re: **Response to City Comments**
 Proposed Residential Development
 2710 Draper Avenue - Ottawa

date: July 22, 2019

file: PG1630-MEMO.25

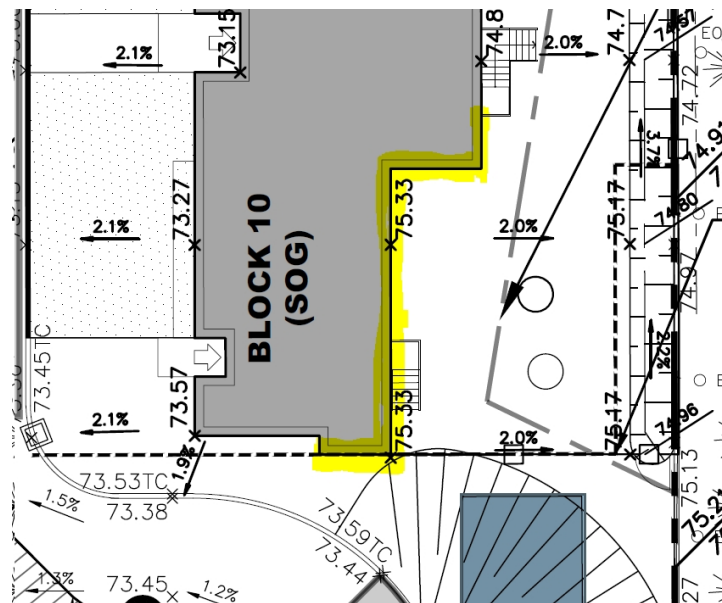
Comment 18: *In accordance with the SPA for Phase 3-1, the Owner is required to coordinate with the adjacent property owner of 2702 Draper Ave. for the realignment of the existing private storm and sanitary services that currently occupy Phase 3-2 Block 10 or shall grant an unencumbered easement for the protection of these services. It is acknowledged that an approximate 4.5 metre easement is now shown on the plan to the granted. Please provide confirmation that any further excavation of these private services will not undermine or impact the adjacent Blocks. A condition within the subject approval will be included to confirm this requirement.*

Response: Upon review of drawing of the following drawings by DSEL: Existing Condition Plan 2781 Baseline Rd, Drawing No. EX-1, Revision 7 dated April 5, 2016 and Grading Plan Fresh Towns - 2710 Draper Avenue Phase 3-2, Drawing No. GP-1, Revision 4 dated July 22, 2019, the existing underside of manholes STMMH-3 and SANMH-161 was estimated to be 70.68 m and 70.41 m respectively. Based on our review, the footings along the southeast corner of Block 10 as shown below should be constructed over a zero entry lean concrete (15MPa) in-filled trench extending to a depth of 72.75 m or lowered to the same elevation to avoid undermining the subject footings during excavation for services.
